# Hurstville Private Hospital Redevelopment Preferred Project Report

<b>Project No.</b>	0019_3
<b>Project Name</b>	Hurstville Private Hospital Redevelopment
<b>Project Address</b>	37 Gloucester Road, Hurstville
<b>Document Title</b>	Preferred Project Report
<b>Issue Type</b>	Final Digital Copy for publication
<b>Client</b>	Hurstville Private Pty Ltd

This Preferred Project Report (PPR) is submitted on behalf of Hurstville Private Pty Ltd in response to the Department of Planning and Infrastructure's (DPI) letter dated 10 January 2013 (Refer Appendix A). The Department's letter is in response to its preliminary assessment and submissions received following public exhibition of the Environmental Assessment for the proposed Hurstville Private Hospital redevelopment located at 37 Gloucester Road, Hurstville (Department Reference: MP11\_0042).

FIGURE 1: PROPOSED SETBACKS TO MINIMISE OPPORTUNITIES FOR OVERSIGHTING DOWN MILLETT STREET

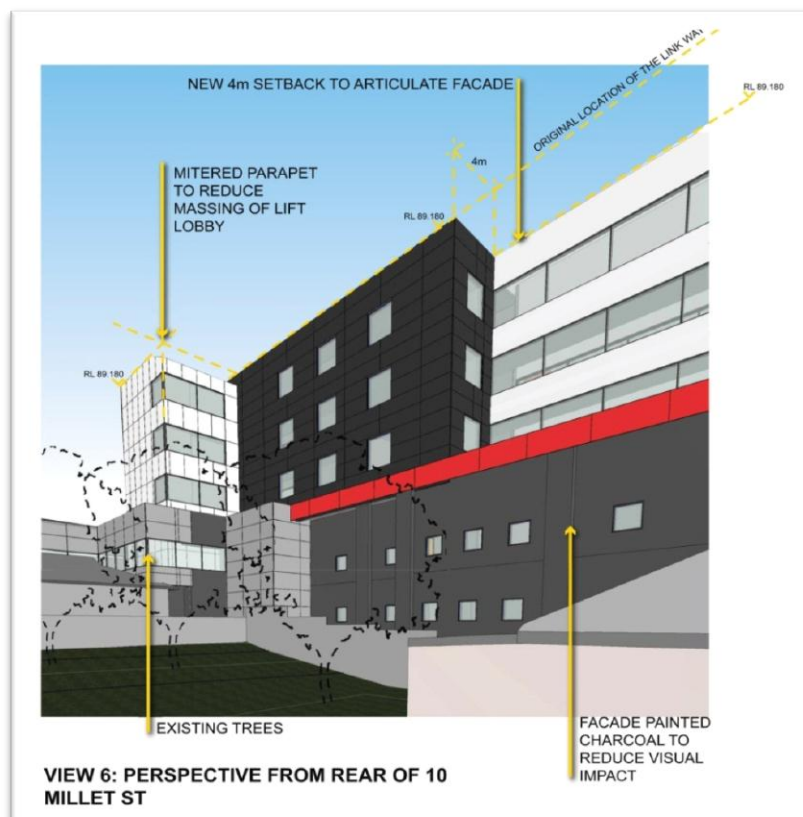
Issue	Comment
Note	Please note that the department's preliminary view is that the proposed stacked parking to the deck over 12 Millett Street is unlikely to be supported. The department has not yet formed a view about whether a smaller deck one car-length in depth should be supported. It is recommended that you revise the proposal accordingly and consider the comments below in light of this.
Relevant EPIs policies and guidelines	<p>Proposed Carparking Deck at 12 Millett St</p> <ul style="list-style-type: none"> <li>Notwithstanding that the proposed carpark can be considered as related development, provide a detailed assessment of the proposed elevated carpark at 12 Millett St against all LEP and DCP controls applying to 12 Millett St (including but not limited to provisions related to parking, built form, setbacks and outbuildings). Demonstrate compliance and highlight and justify any non-compliance (see also below under residential amenity in relation to assessing impacts)</li> </ul>

The proposed deck over the at-grade car park at 12 Millett Street which would have been able to accommodate tandem car parking and a turning bay for service vehicles has been redesigned to accommodate only the turning bay and 4 car spaces. This will reduce the size of the deck. The depth is reduced from 12.066 metres to 8.466 metres. The width is 18.589 metres.

The amended deck design aligns with the northern boundary of 16 Millett Street where the rear villa garage is located.

The deck is set back 1.382 metres from the southern boundary. There is a set of stairs from the upper to lower deck of the car park on the immediate southern boundary and within the setback.

FIGURE 2: LOCATION OF EXISTING UPPER BASEMENT PARKING AND FENCING BETWEEN HOSPITAL AND ADJOINING PROPERTY. PARKING LEVEL WILL BE RETAINED AND ENCLOSED, FENCING WILL BE RETAINED. A SECURITY GATE WILL BE PLACED AT THE ENTRANCE TO THIS LANEWAY AND WHERE THE BINS ARE CURRENTLY LOCATED.

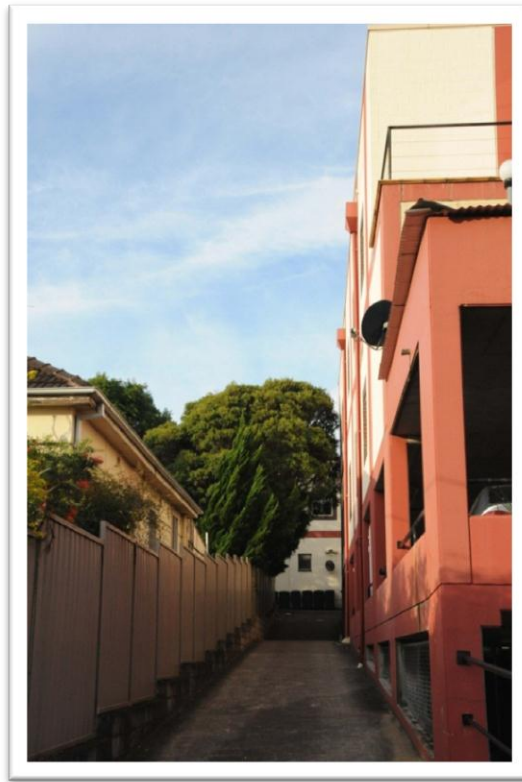
<p>with the proposed 'climber' landscaping</p> <ul style="list-style-type: none"><li>• Delete the bin collection enclosure from the ground floor corner, relocate its functions inside the main building envelope, and replace with low level landscaping</li><li>• Reduce the number and extent of vehicle entries on Millett St (see below under Transport and accessibility) and clarify what elevational treatments are proposed to vehicular openings to avoid an industrial appearance</li></ul> <p>Crime prevention through environmental design</p> <ul style="list-style-type: none"><li>• Provide further information about the safety of the 'laneway'/accessway connecting Gloucester Rd and Millett St following its closure by the proposed development and necessary gates or other security</li><li>• Identify which carparking spaces are "staff-only car park areas with restricted access after hours" in accordance with the CPTED Report</li><li>• Provide further information about any roller shutters or access restrictions to the basement carpark (noting the CPTED Report Appendix One: <i>Hurstville Private Hospital Security Policies &amp; Procedures</i>)</li></ul>

At 'ground' level, the upper basement parking and the existing fenestrations will be retained, permitting natural ventilation. The façade will be painted a charcoal colour to reduce visual impacts.

The existing perimeter fencing between the Hospital property and adjoining residential property will be retained.
